FINAL ENVIRONMENTAL IMPACT REPORT

Final Environmental Impact Report

PLAN BAY AREA 2050+

**Regional Transportation Plan (RTP)/
Sustainable Communities Strategy (SCS)**

Figure 3.10-4: Groundwater Basin Prioritization

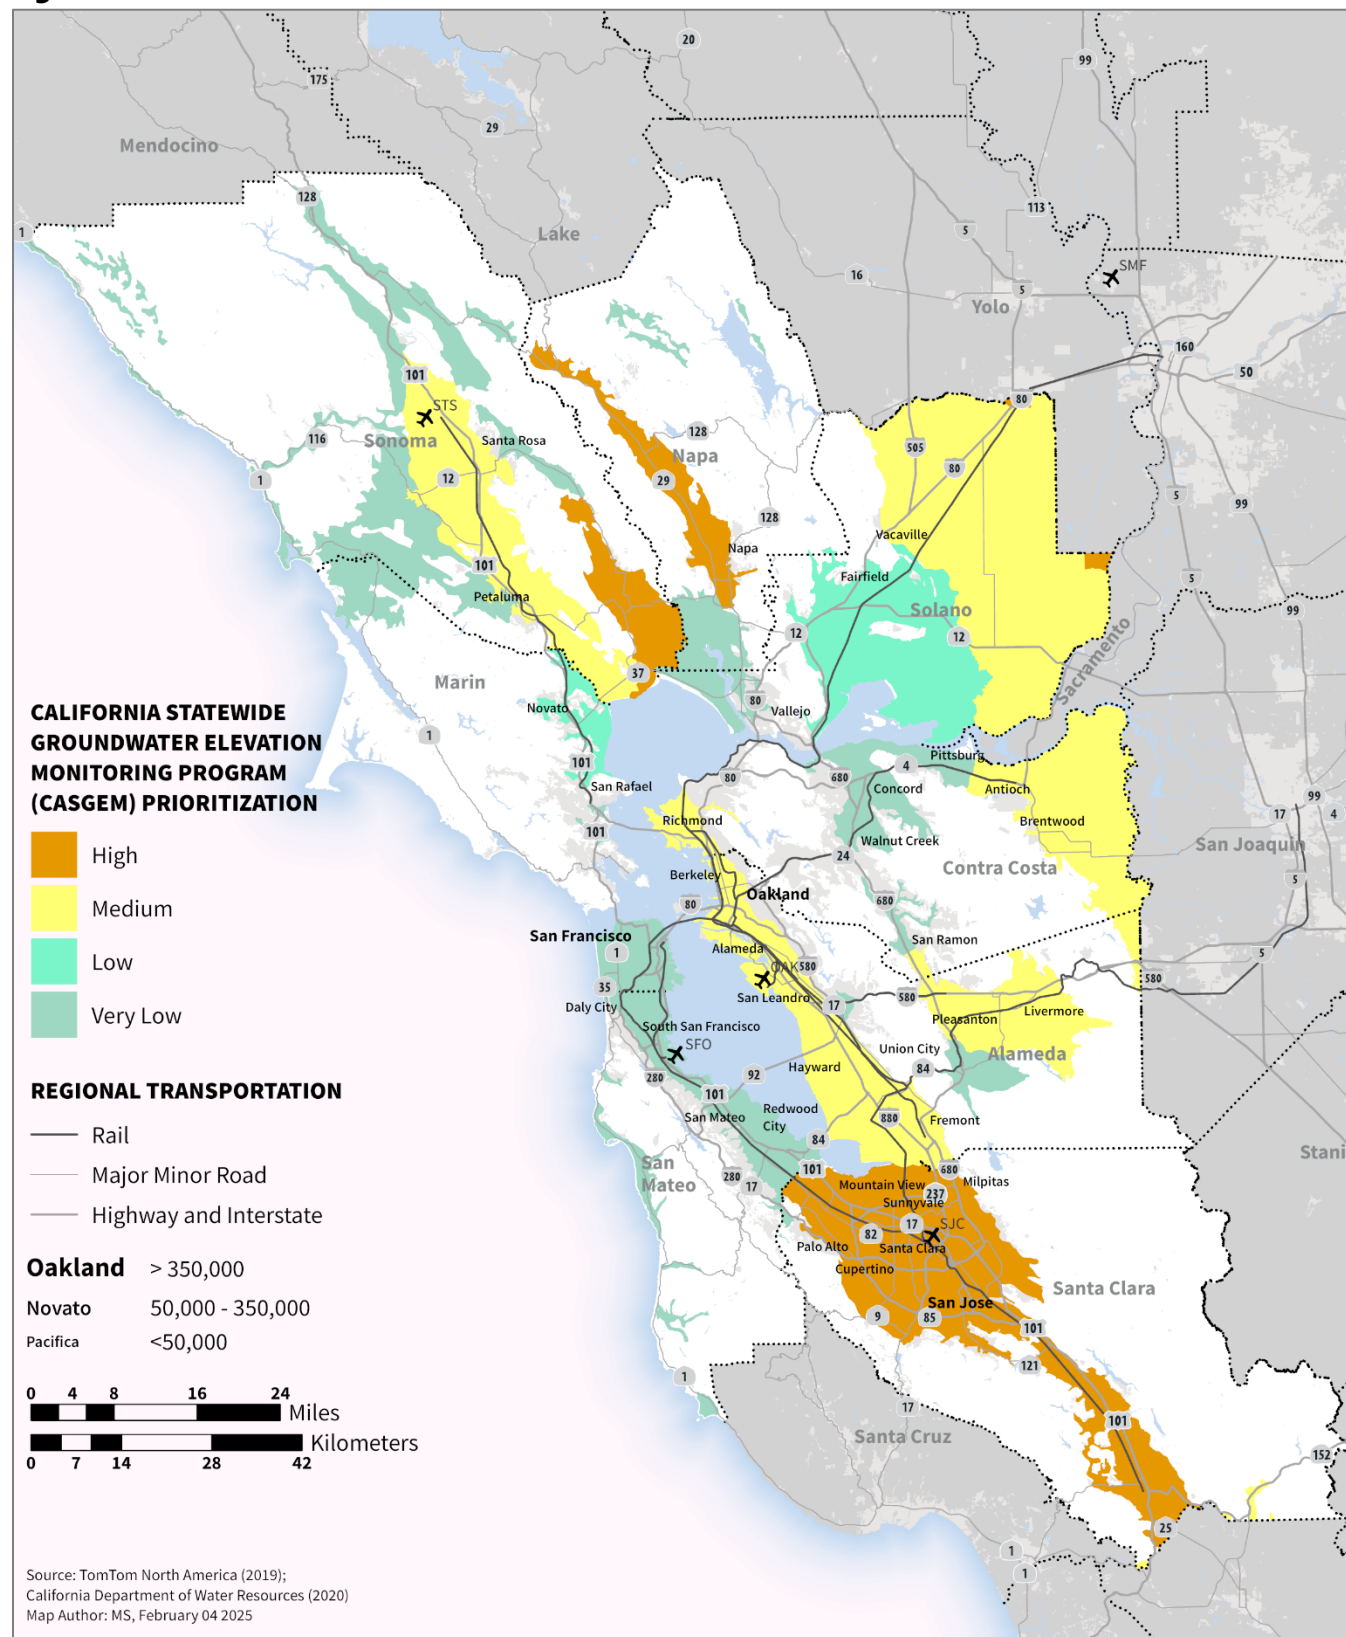
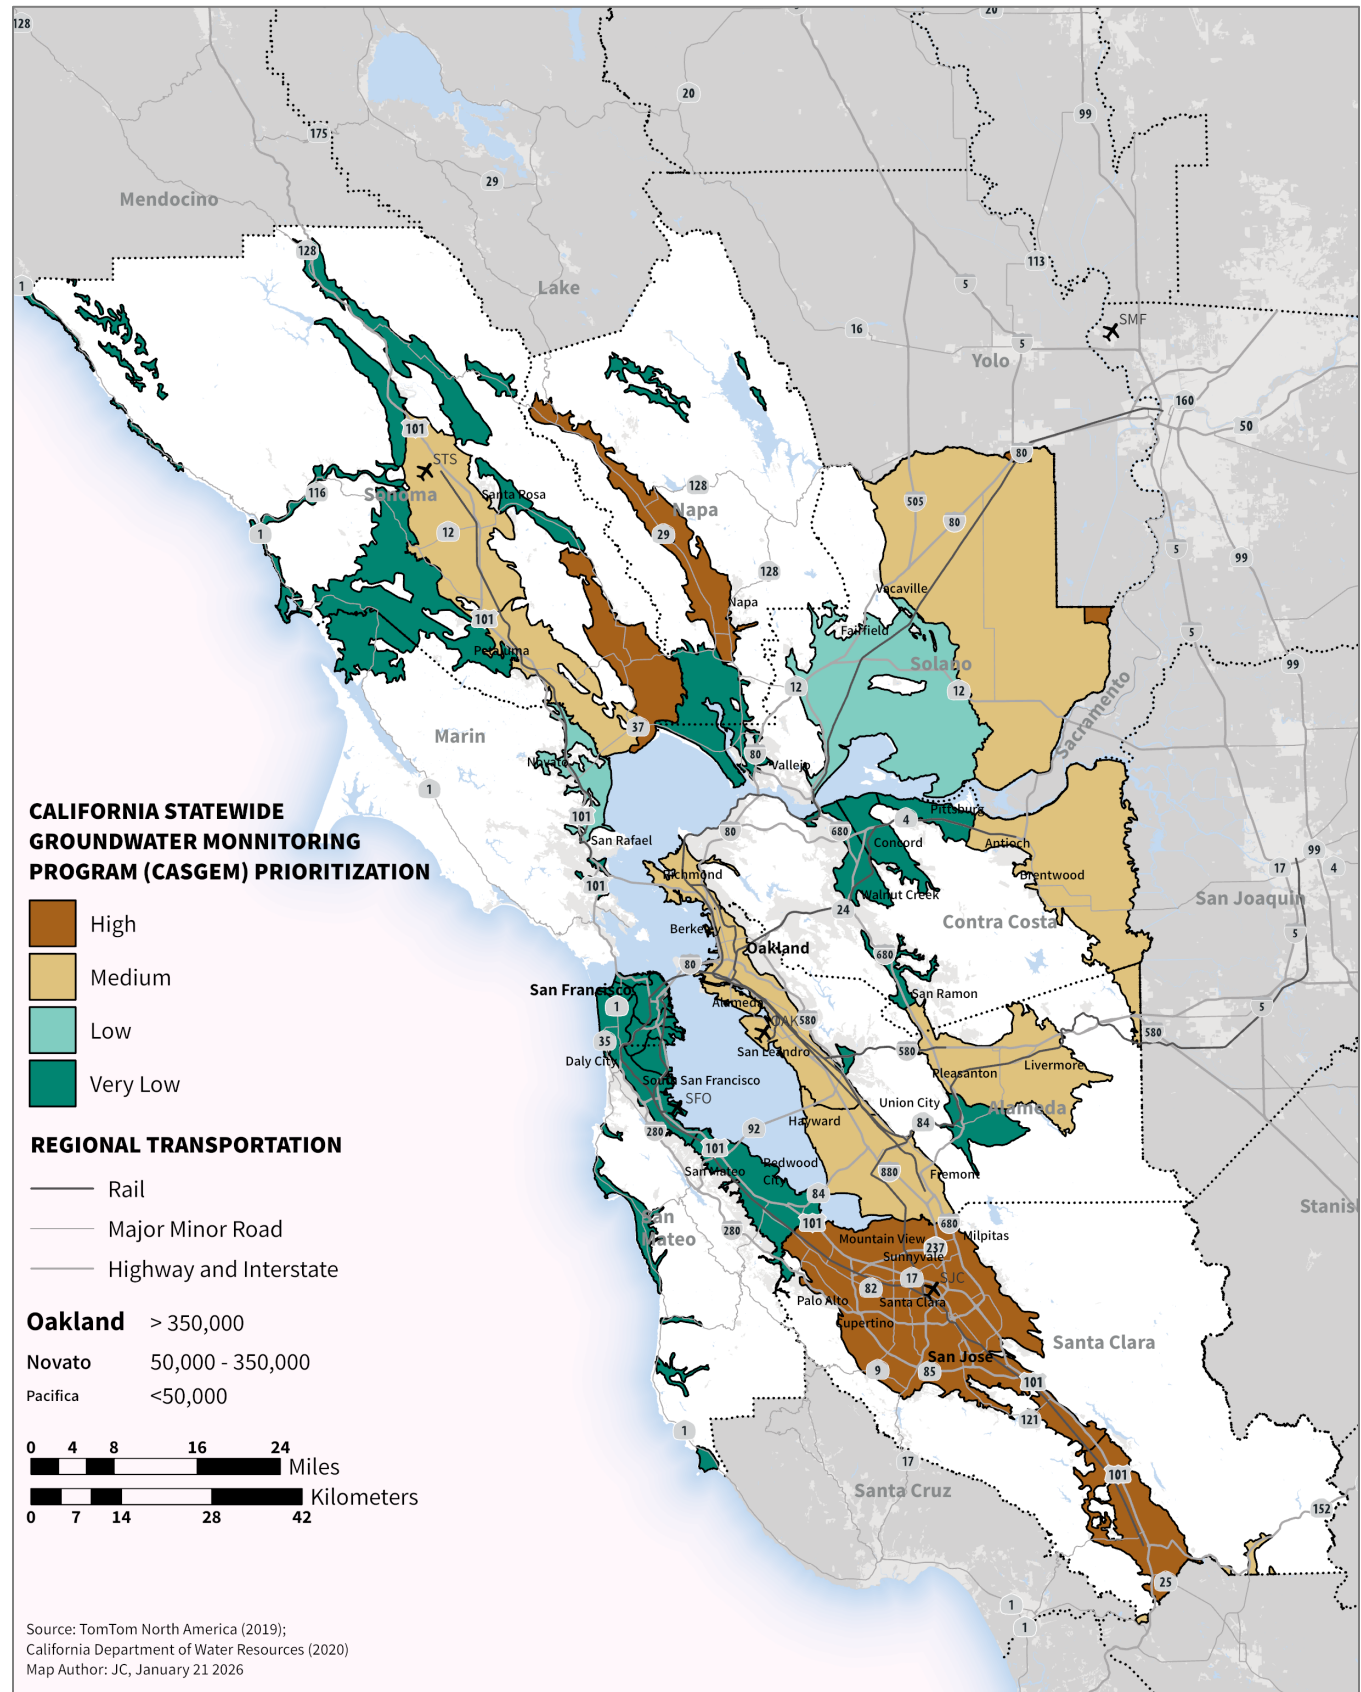
- c. Figure 3.10-4 of the Draft EIR provides a map of groundwater basins designated as high or medium priority. In the figure, basin boundaries are not shown, and this makes adjacent basins of the same priority appear to be combined (a single basin). ACWD recommends that basin boundaries be added to the map to avoid confusion.

Figure 3.10-4 of the Draft EIR has been revised to clearly depict the boundaries of the groundwater basins to provide clarity where adjacent basins share the same priority designations. See Section 3.7, Draft EIR Section 3.10, “Hydrology and Water Quality,” of the Final EIR, which provides the revised figure. This revision is informational in nature and does not change the analysis, impact determinations, or conclusions in the Final EIR.

In response to Comment A7-5, the following revision has been made to Figure 3.10-4 on page 3.10-15 of the hydrology and water quality section of the Draft EIR:
